MONTICELLO NUCLEAR GENERATING PLANT

AMENDMENT TO FACILITY OPERATING LICENSE

Amendment No. 27
License No. DPR-22

SAFETY EVALUATION BY THE OFFICE OF NUCLEAR REACTOR REGULATION

Figure 1 RHR Intertie Modification

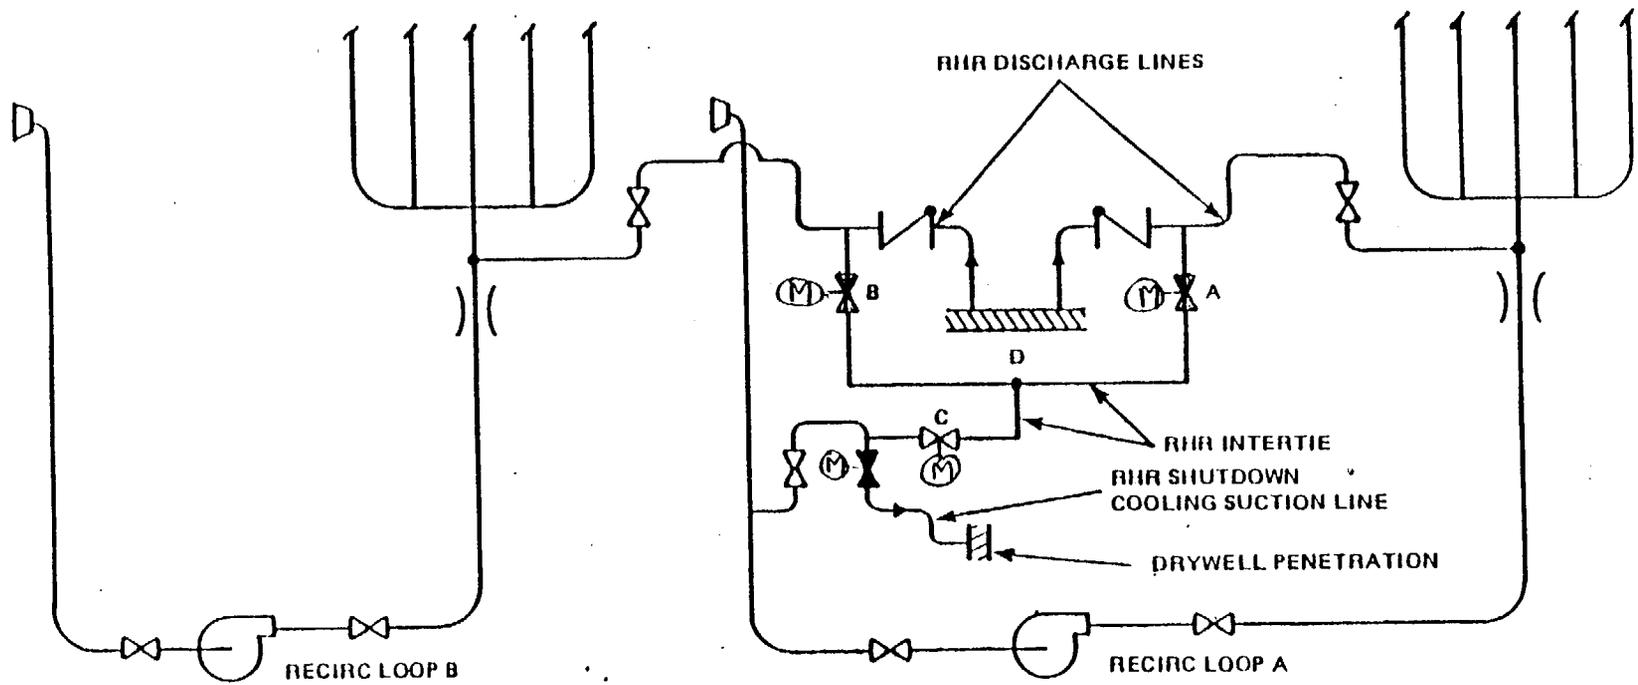
By letter dated May 29, 1984 Northern States Power Company (the licensee) proposed to change the Technical Specifications for the Monticello Nuclear Generating Plant to add surveillance and operability requirements for intertie line valves, add limitations on the use of the intertie line, and delete Technical Specifications (TSs) pertaining to the crosstie line. These Technical Specification changes stem from changes in piping configuration during the current pipe replacement outage, in which an intertie line has been added and the crosstie line has been removed. Additional clarifying information was presented by the licensee by letter dated August 16, 1984. According to the licensee there have been incidents of waterhammer in the recirculation system when the system was operating during shutdown cooling. The General Electric Company conducted an analysis to determine the best method of preventing waterhammer and providing for warmup of an idle recirculation loop. The analysis indicated that a residual heat removal (RHR) intertie line as shown in Figure-1, was the best alternative. A four-inch intertie line was shown to provide sufficient flow to minimize collection of steam bubbles in the high points of the recirculation system piping and RHR suction and discharge pipes as long as the flow is circulated continuously during depressurization. This is a design enhancement intended to minimize the potential for waterhammer in the circulation system. Three motor operated valves, as shown in Figure-1, will be installed for isolation purposes. The two isolation valves which are normally closed during normal plant operation will receive a closure signal on low pressure coolant injection (LPCI) actuation to prevent a reduction in LPCI flow delivered to the reactor under accident conditions.

The new intertie line would be normally isolated during plant operation with MO-4085A and MO-4085B closed and MO-4086 open. The line would be used:

1. When the plant is proceeding to cold shutdown, the valves would be opened after the reactor is out of the run mode and prior to depressurizing the reactor.

2. To prevent a recirculation loop waterhammer in a hot isolated loop during primary system depressurization. In this case, MO-4985A and MO-4085B would be opened and MO-4086 would be either open or closed, depending on which loop is isolated.

Since the intertie valves are assumed to be open at the time of a postulated accident, the effect of the intertie on the DBA break size was evaluated. NRC-approved evaluation models were used in the analysis. Assumptions and models used in the latest Monticello LOCA analysis (Ref. 1) were also used in the new analysis.

The intertie is a four-inch line with a flow area of 0.08 ft². If this flow area is added to the former maximum flow area, the new 100% DBA break size becomes 4.09 ft². The addition of the intertie flow area increases the maximum flow area by about 2%. The analysis performed for the new maximum flow area indicates that the difference in the time of core uncover is less than one second. There is no change in the limiting break size (1.36 ft²) with or without the intertie. There is no significant impact on the Appendix K analysis.

1. Quarterly cycling of MO-4085A, MO-4085B and MO-4086. In addition, these valves will be included in the Monticello ASME Code, Section XI, Pump and Valve Testing Program.
2. Requirement for operability of MO-4085A and MO-4085B at all times. In the event of an inoperable valve, actions are specified to assure full LPCI flow.

3. Limitations on use of the intertie line. Flow will not be allowed in the line if the reactor is in the run mode.
